REMSSEN-LAKE PLACID TRAVEL CORRIDOR PROPOSED FINAL AMENDMENT / FINAL SUPPLEMENTAL EIS

**1996 Remsen-Lake Placid Travel Corridor
Unit Management Plan /
Environmental Impact Statement**

February 2016

Review of Rails-With-Trail Design Proposal by Trail with Rail Action Committee (TRAC)

Hoel Pond

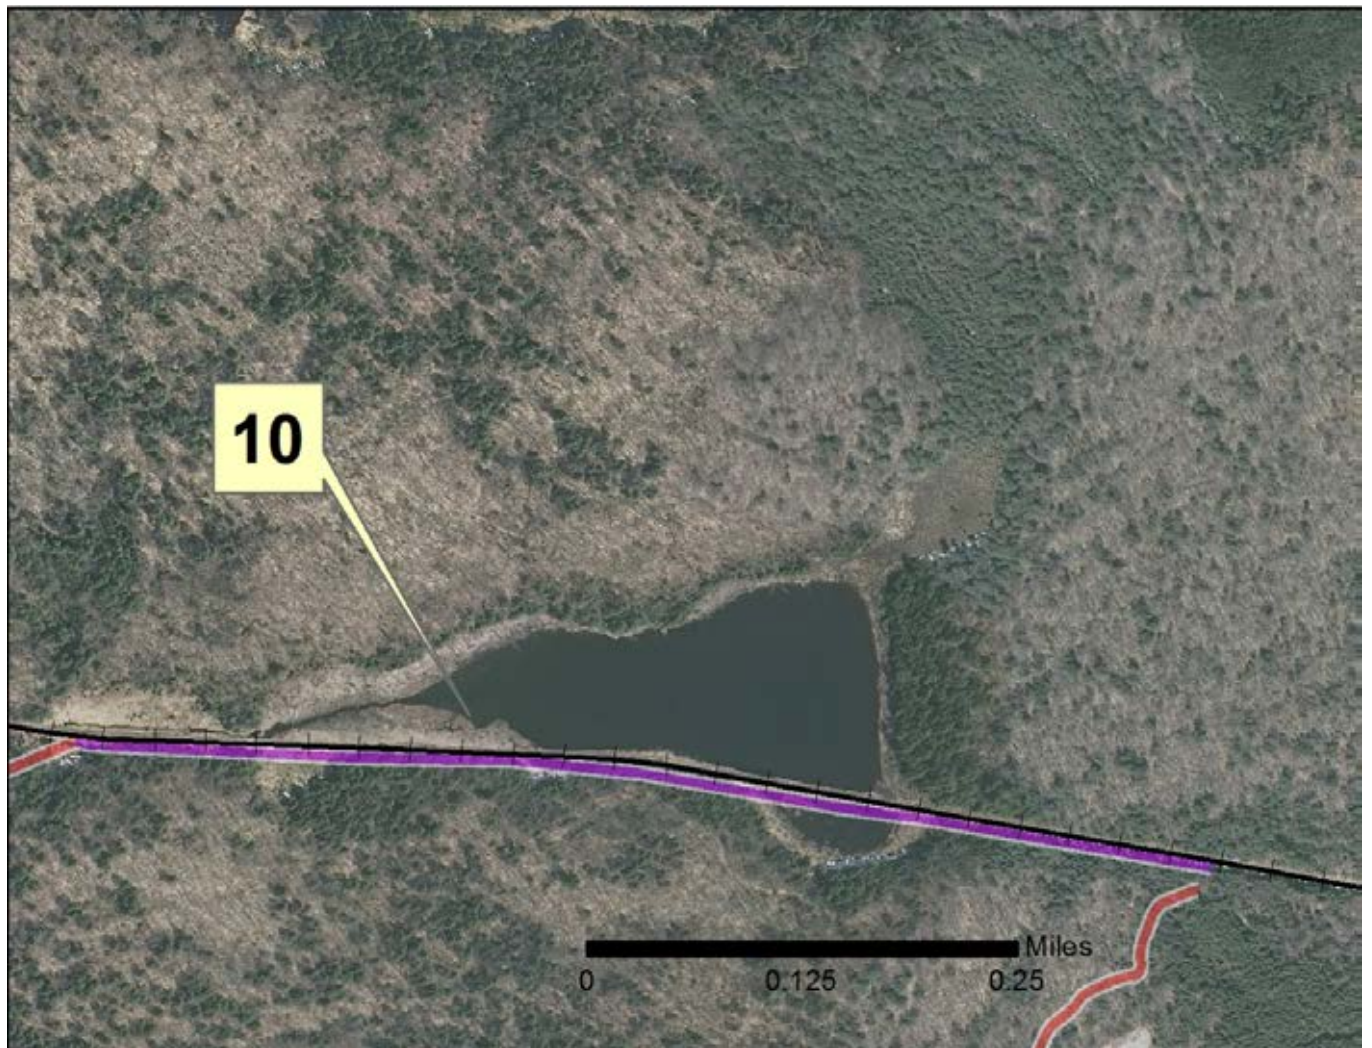
TRAC's suggested route in this map, at **Map Point #8**, goes around Hoel Pond. It starts as a herd path on the southeast side of the pond, and diminishes going west, where there are currently some primitive campsites. It is feasible that this trail system can be upgraded. This proposed segment, however, bypasses potential future access locations for people with disabilities. The Corridor offers easier water-access potential than the Hoel Pond loop.

At **Map Point #9**, shows the town road being utilized as an alternative route in the TRAC proposal, heading north from the country club, has private property at the end. Any connection to the Corridor from this road would need to be negotiated with the private landowner.

At **Map Point #10**, TRAC's "Along Corridor" segment goes through wetlands and over an open water causeway, making this proposed segment infeasible.

TRAIL SECTION:
Lake Clear (no aerial photo maps needed)

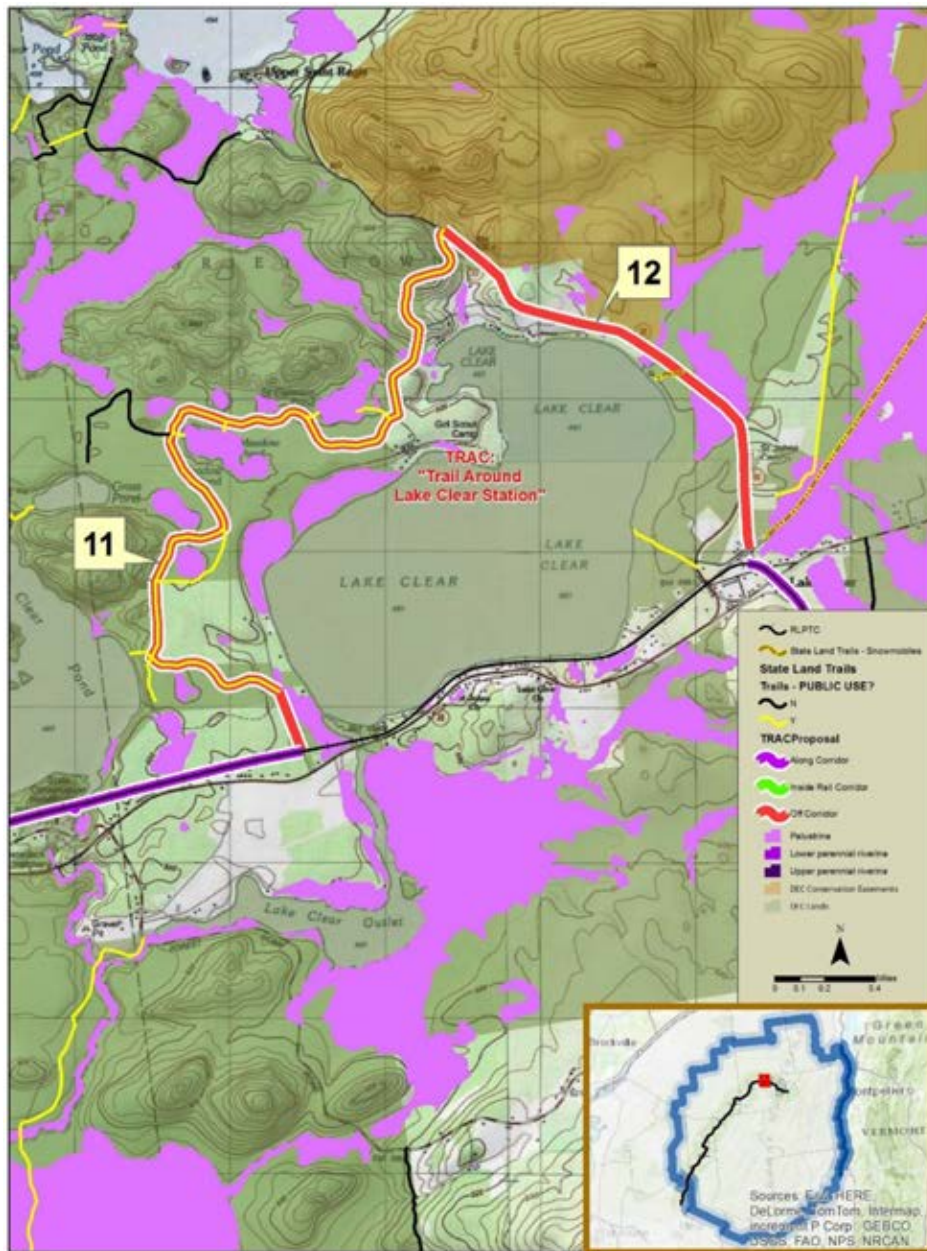
Map Point #11 - Snowmobiles and bikes are prohibited, by the Adirondack Park State Land Master Plan, in the Canoe Area.

Map Point #12 shows TRAC's segment along Route 30 which is not recommended for safety reasons, and would most likely reduce or eliminate family-oriented recreation. A possible alternative to that segment is on the north side of that road, on conservation easement land, but a crossing of Route 30 is not recommended for safety reasons, as well. Additionally, a trail on that easement would need to detour north, around significant wetlands.

TRAIL SECTION: McCauley Pond

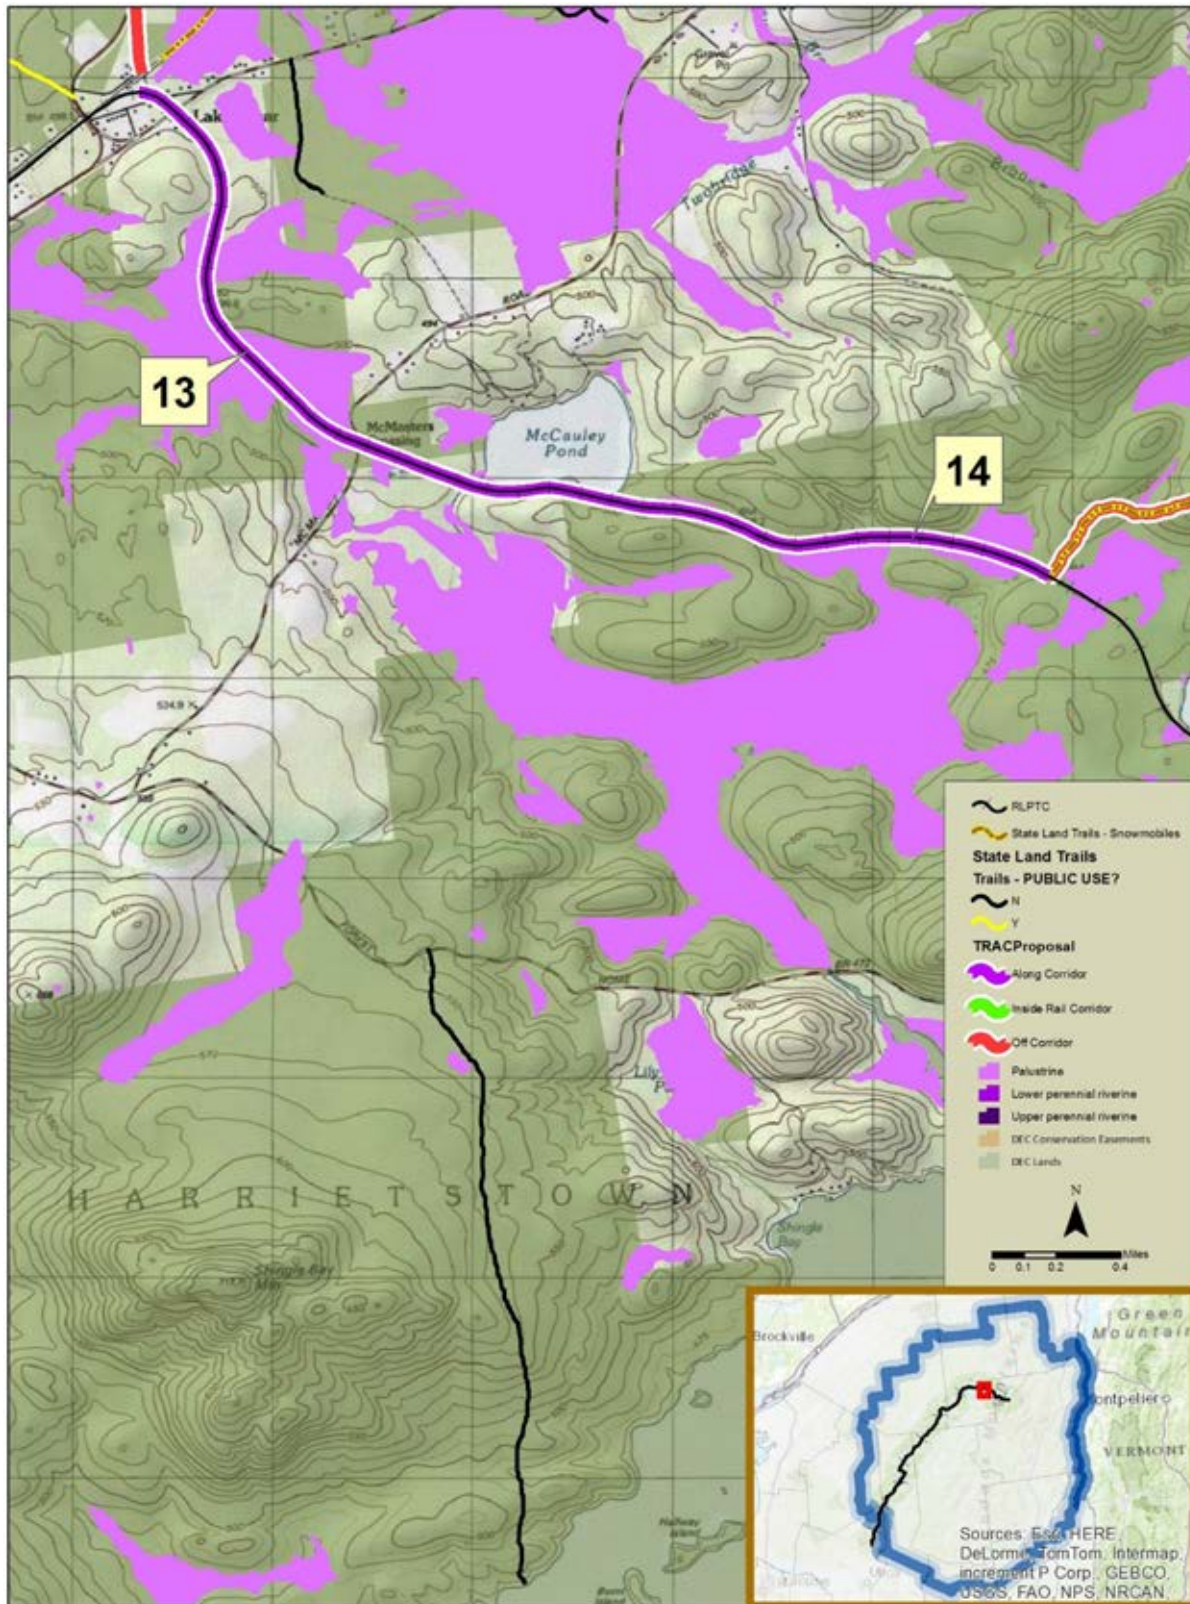
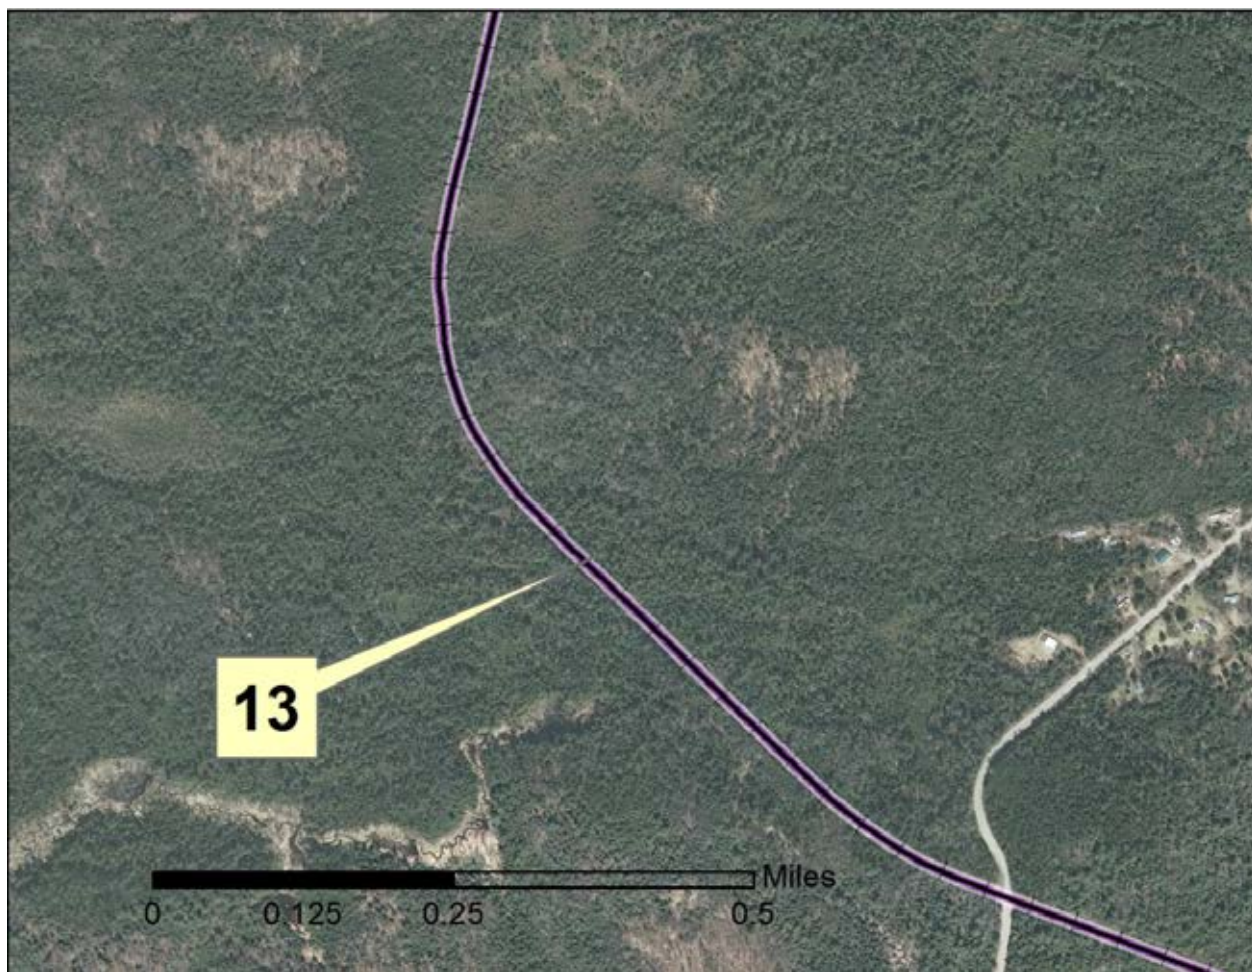
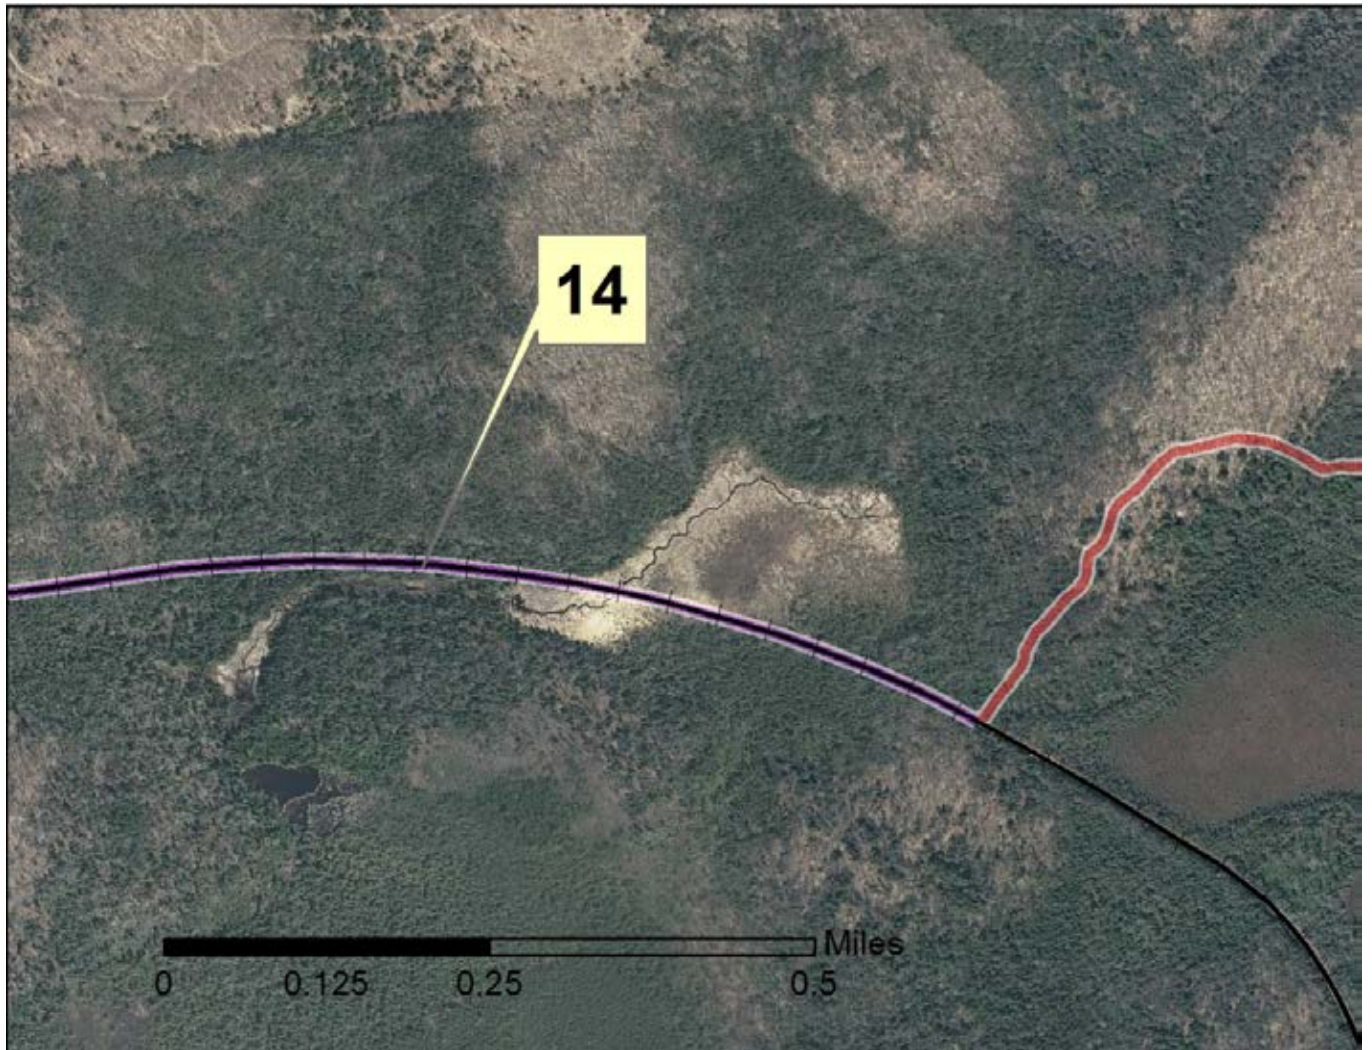
Map Point #13 shows where TRAC proposes a segment approximately 1 mile “Along Corridor”, which would result in adverse impact or loss of regulated wetlands.

Map Point #14 shows where TRAC proposes a segment approximately 0.7 mile “Along Corridor”, which would result in adverse impact or loss of regulated wetlands.

Lake Colby/Saranac Lake

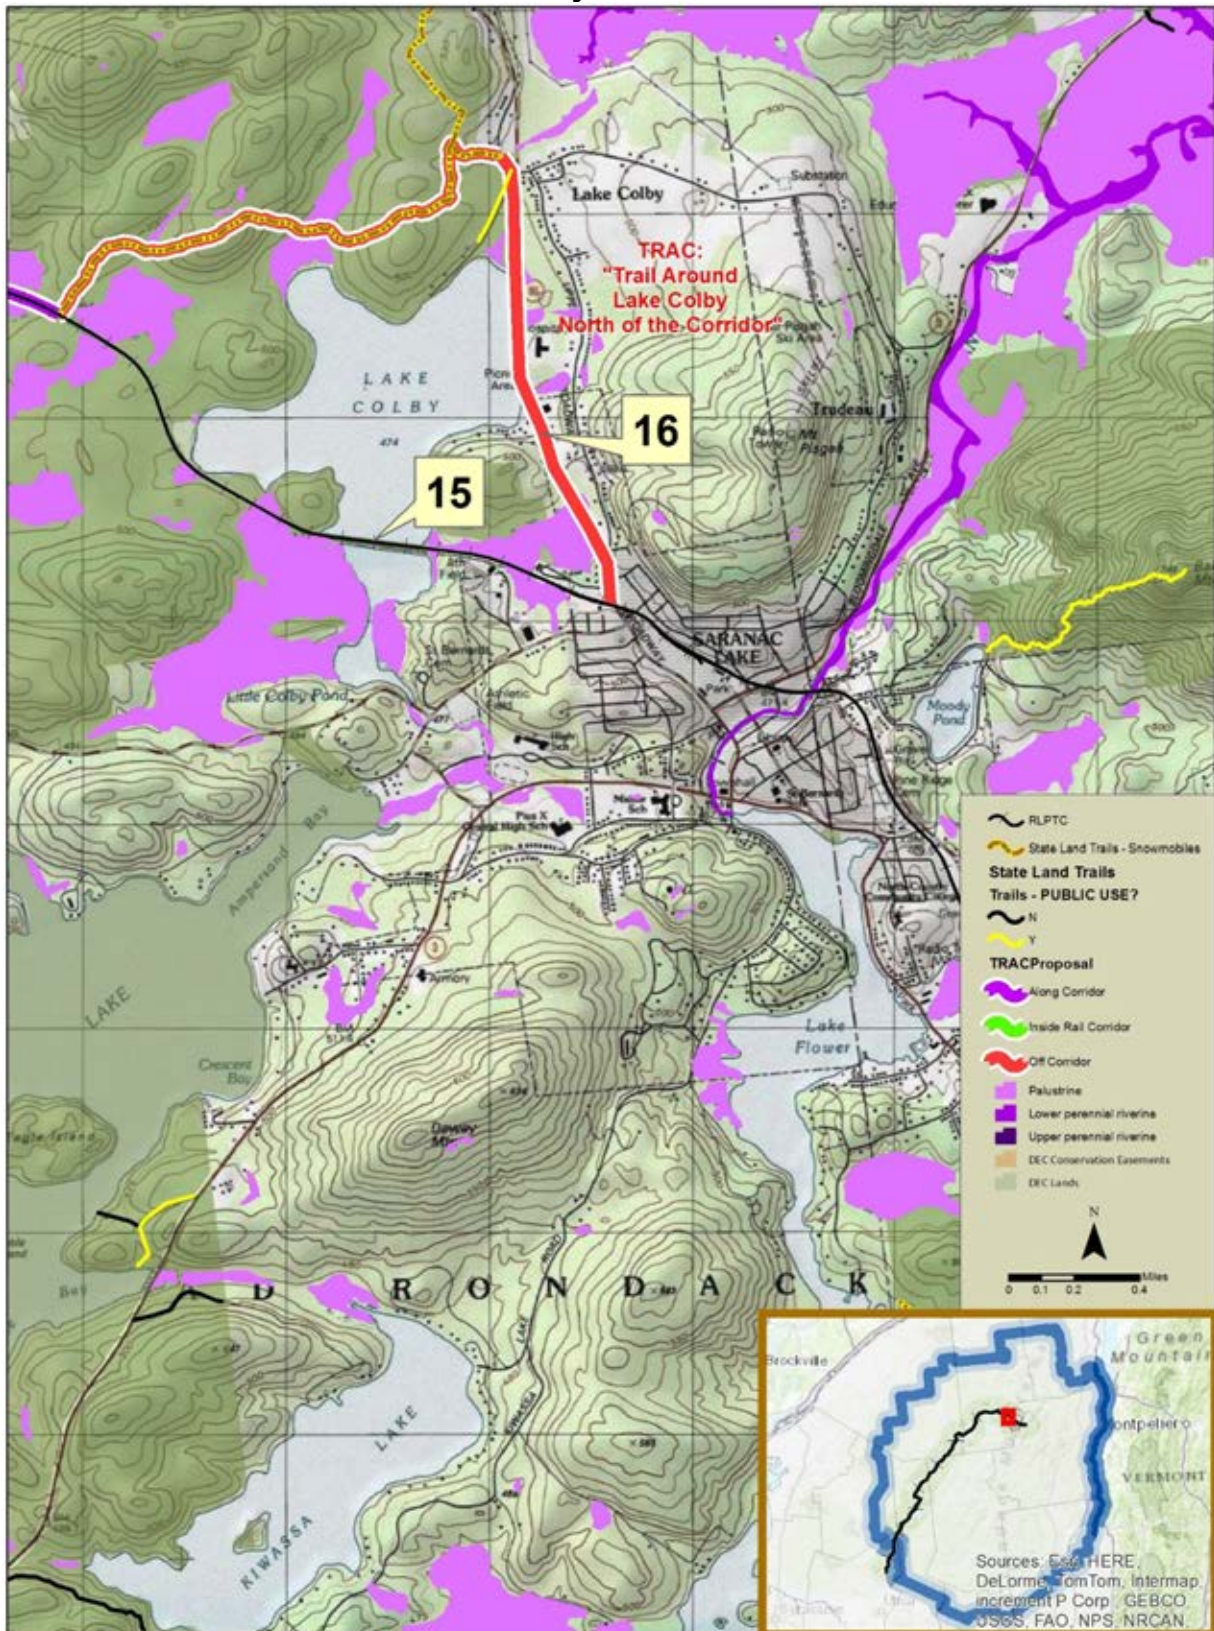
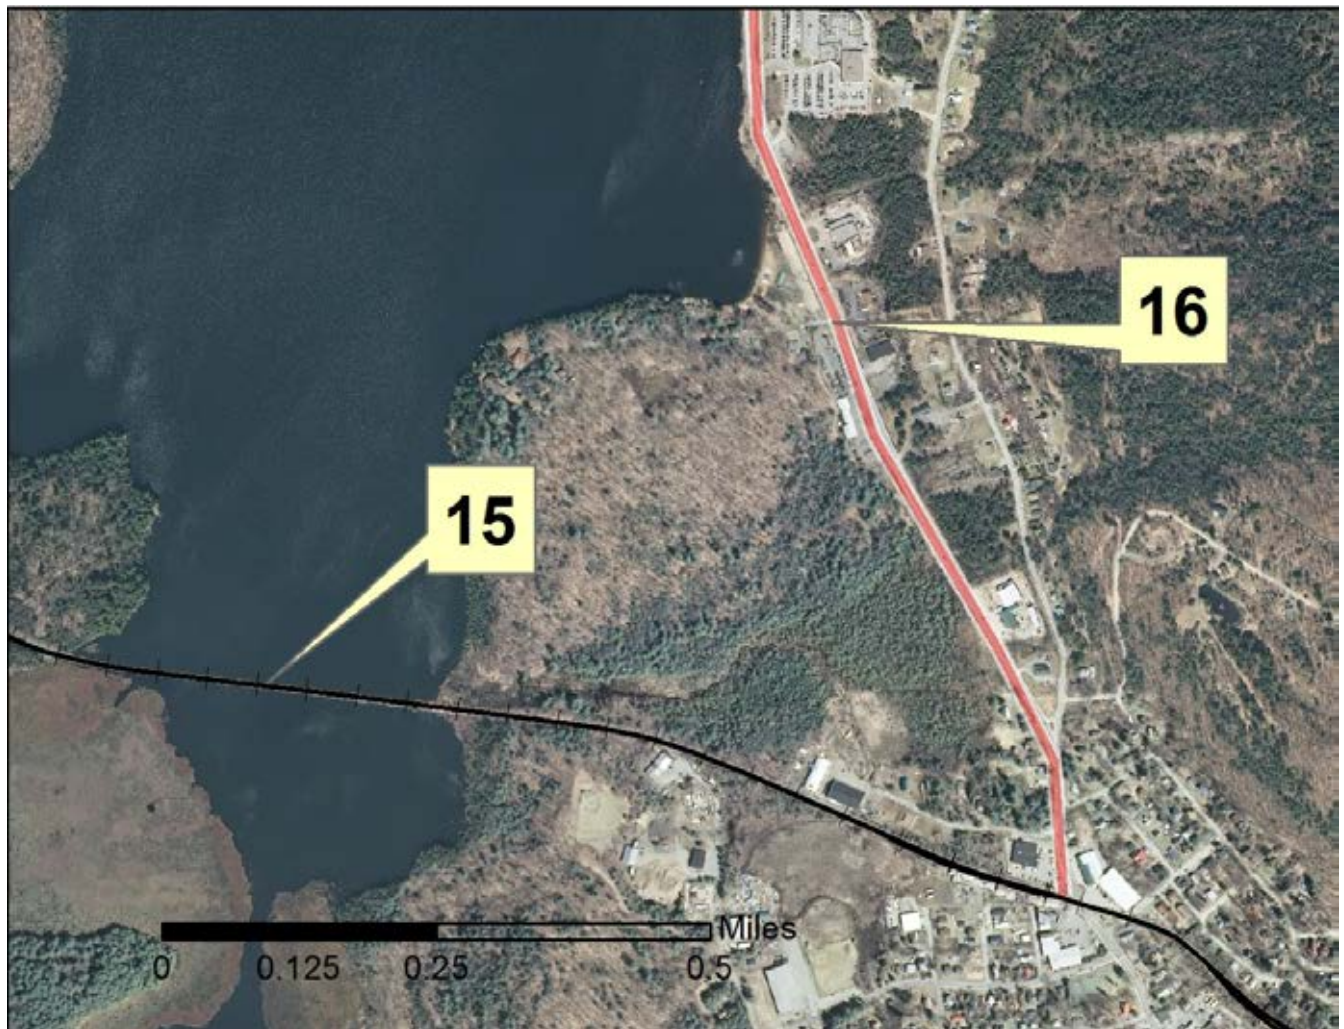
TRAC's route around Lake Colby bypasses the Lake Colby causeway (**Map Point #15**), which has potential to become fishing and paddling access for people with disabilities.
